## **Civils Design Report**

## **Residential Development**

**Ballymount Road Lower,  
Walkinstown,  
Dublin 12**

**Job No:** D1752  
**Architect:** Meitheal Architects  
**Date:** April 2024  
**Local Authority:** South Dublin County Council  
**Pre Planning:** LRDPP0118/23  
**Revision:** PL1

### STORM WATER & FOUL SEWER DRAINAGE LAYOUT

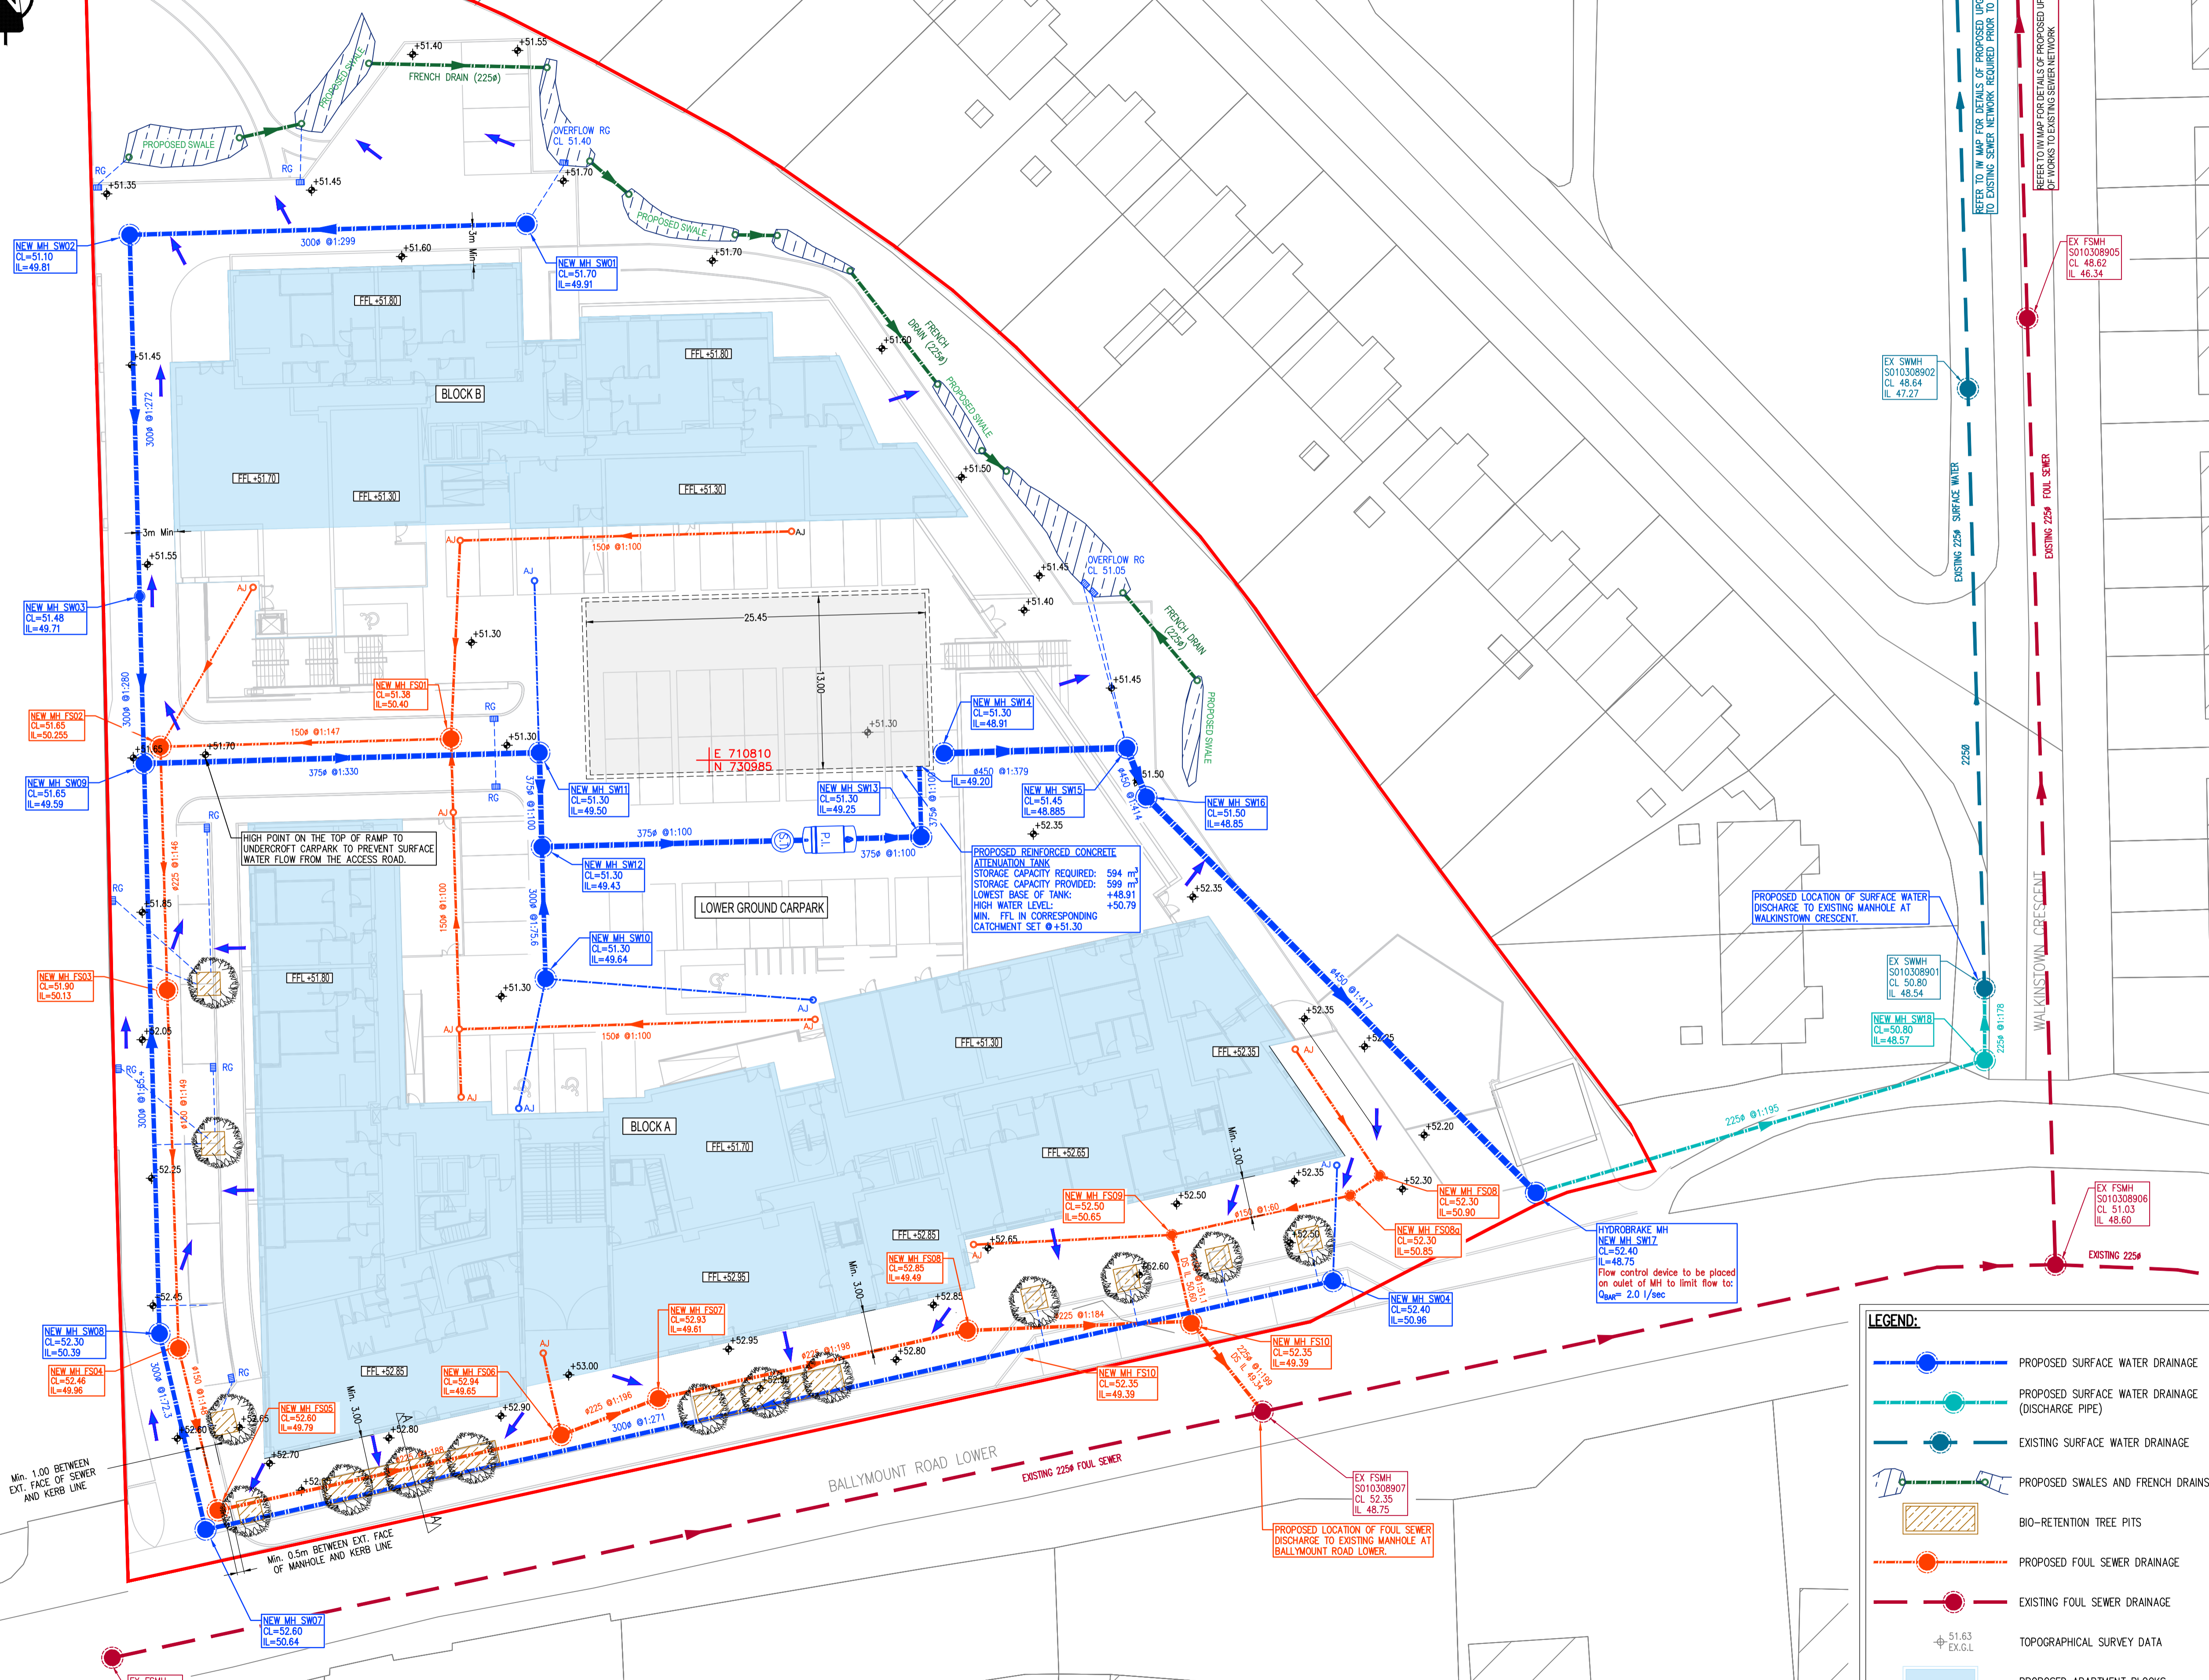
The drainage layout drawing states that 599m<sup>3</sup> is provided in the attenuation tanks but a volume of 614m<sup>3</sup> has been provided within the model. While the simulation results would suggest that a volume of 599m<sup>3</sup> is likely to be sufficient, the model should be updated to reflect the actual site proposals to ensure compliance.

10	The drainage layout drawing states that 599m3 is provided in the attenuation tanks but a volume of 614m3 has been provided within the model. While the simulation results would suggest that a volume of 599m3 is likely to be sufficient, the model should be updated to reflect the actual site proposals to ensure compliance.	KB to update the model to reflect the actual storage volume provided.	Attenuation volume calculation is show on KB Ref. D1752-KB-XX-XX-DR-C-0002-RC Tank, Trench & Manhole Details_RevP2. The storage volume figures in the Flow model were adjusted to provide a volume of 599m3, which matches the one indicated on the drawing.	Acceptable (Note: Updated Flow calculations have not been provided)
11	The Planning drawings proposed StormTech attenuation structures but the tender drawings propose RC tanks. Typically RC tanks should only be used where no other solution exists and they do not provide any water quality benefits, whereas the Isolator Row in the StormTech units provides some benefits.	KB to advise why RC tanks are now proposed and whether this has been discussed with SDCC.	The reason the RC attenuation tanks are proposed instead of the StormTech attenuation system are as follows: 1) Interception storage volume is provided throughout the diverse SuDS features proposed across the site, thus on-site infiltration is required through the base of the tanks. 2) All volumes generated by 1 in 100-year storms of all durations is now catered for by the RC attenuation tank. Therefore, the required attenuation volume has increased. To avoid interfering with structural foundations a concrete tank has been adopted.	Acceptable subject to SDCC agreement.

Updated drainage layout (D1752-KB-XX-XX-DR-C-0001-Drainage Layout\_RevP3 ) and attenuation tank details (D1752-KB-XX-XX-DR-C-0002-Attenuation Tank Details\_RevP3) drawings were issued on 13<sup>th</sup> December 2022. These showed replacement of the previously proposed split RC attenuation tank with a singular RC attenuation tank. The plan area has increased marginally, from 322m<sup>2</sup> to 331m<sup>2</sup>, whereas the invert level and top of tank level have not changed. This change is not expected to have an impact on the design and the feedback form remains valid. The audit is therefore, considered closed.

BASE DETAIL - Underground attenuation tank  
Scale 1:250

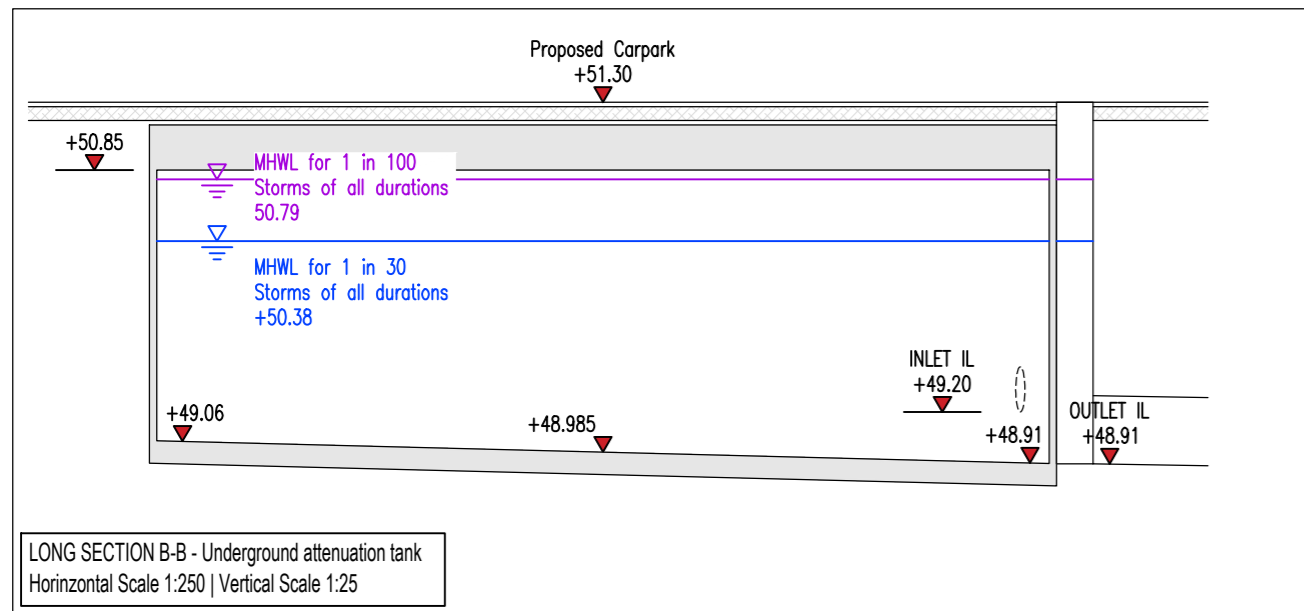
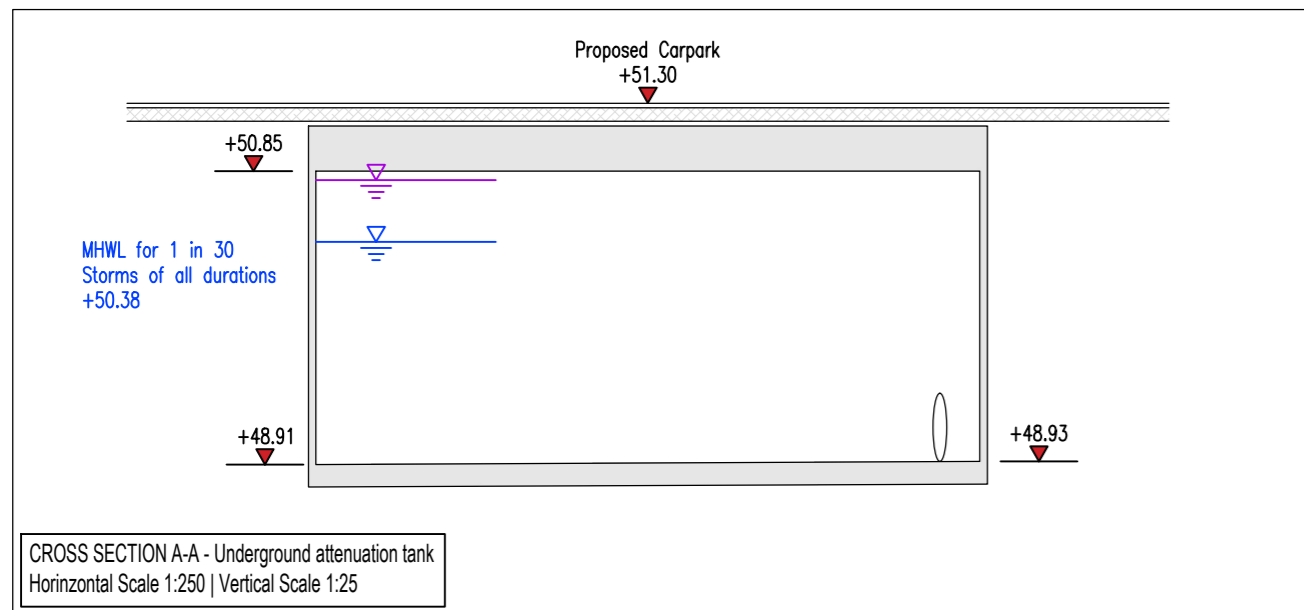
Harvesting	
Petrol Interceptor	Proposed upstream of the attenuation tank.
Attenuation	2 nr. RC attenuation tanks with a combined capacity of 599m <sup>3</sup> shown on drawing DR—0001. The planning drawings proposed a StormTech attenuation structure, and it is not clear why this has changed or if it has been agreed with SDCC.  <b>KB to advise why RC tanks are now proposed and advise whether this has been discussed and agreed with SDCC.</b>
Other	N/A

The Planning drawings proposed StormTech attenuation structures whereas the tender drawings propose RC tanks. Typically, RC tanks should only be used where no other solution exists and they do not provide any water quality benefits, whereas the Isolator Row in the StormTech units provides some benefits.
